Project Name: Coushatta Education Building

Project Number: 24.0002607.000

Addendum 6

C2.01

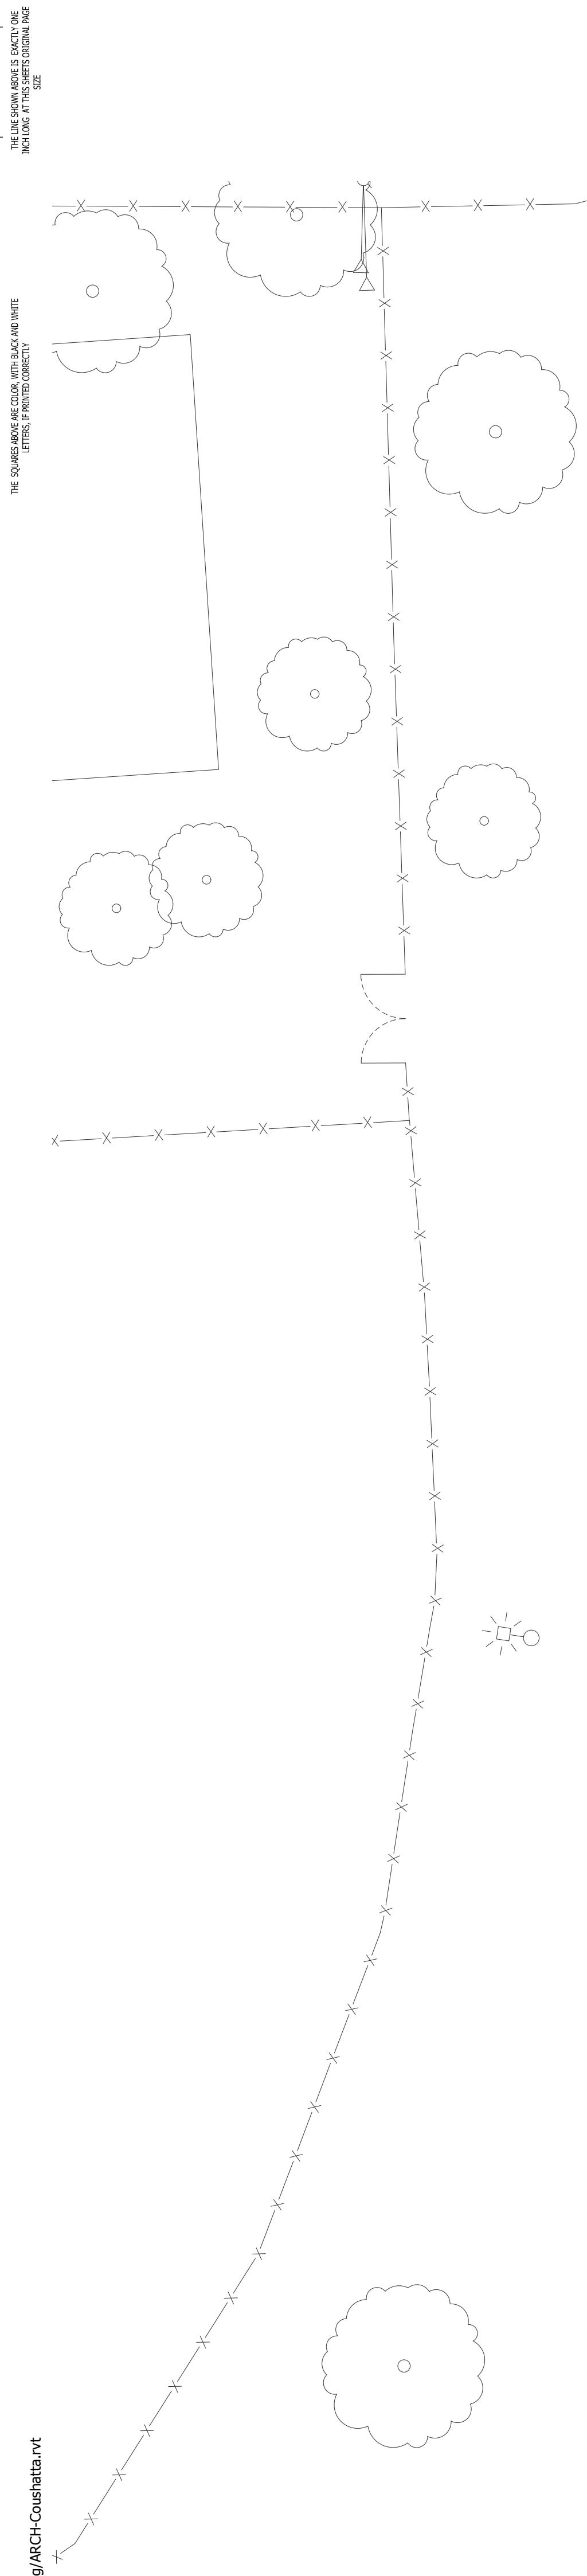
1. Update 1/C2.01 plan to include dashed line and plan note indicating Limits of Construction.
